RE: Additional Riprap and Streambed Cobble Placement
Upper Clear Creek Mitigation Site (UCCMS) Project

UPPER CLEAR CREEK MITIGATION SITE SITE DETAILS

L4.2

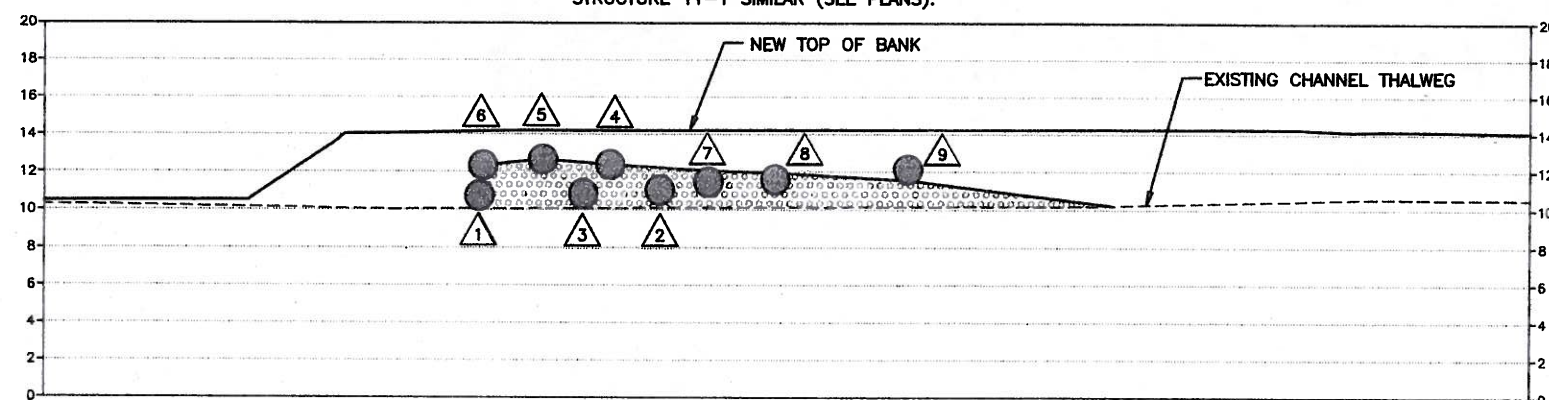
An additional approximate 35 tons (22 CY) of riprap and 40 tons (25 CY) of cobble was necessary to address a Request for Information (RFI) that ACI submitted to the Port of Tacoma (Port). The construction plans excluded riprap and cobble from an area directly north of channel deflector structure 11-2 where the existing channel was realigned further east of the BNSF railroad embankment. ACI expressed difficulty installing riprap that only extends part way down the proposed left (west) bank slope to an elevation of 14 feet. Stable placement of riprap to this elevation would be difficult without additional riprap placement that extends to the proposed channel bed elevation of 10.5 feet (to support the upper material placement). Furthermore, by not adding riprap in this area, there was a risk of erosion at this location during high flows which could lead to bank failure. To address these constructability issues, the design plans were revised to include placement of additional riprap and cobble (see attached revisions to Drawing L4.2 and cross section E from Drawing L4.9).

ADDITIONAL RIPRAP (APPROX. 8' WIDE) SLOPED AT 2H:1V
TO MATCH DESIGN GRADE AT ELEV. 14'

- TOE OF RIPRAP:
TOP OF ROCK ~ ELEV. 10'
BOTTOM OF ROCK ~ ELEV. 8'

- COBBLE TOE AT
ELEV. 10'
TRANSITION COBBLE
OVER RIPRAP TO
FINAL GRADES
SHOWN.

✓ MAINTAIN SLOPE
GEOMETRY PER
DESIGN ON SECTION
E, DWG L4.9
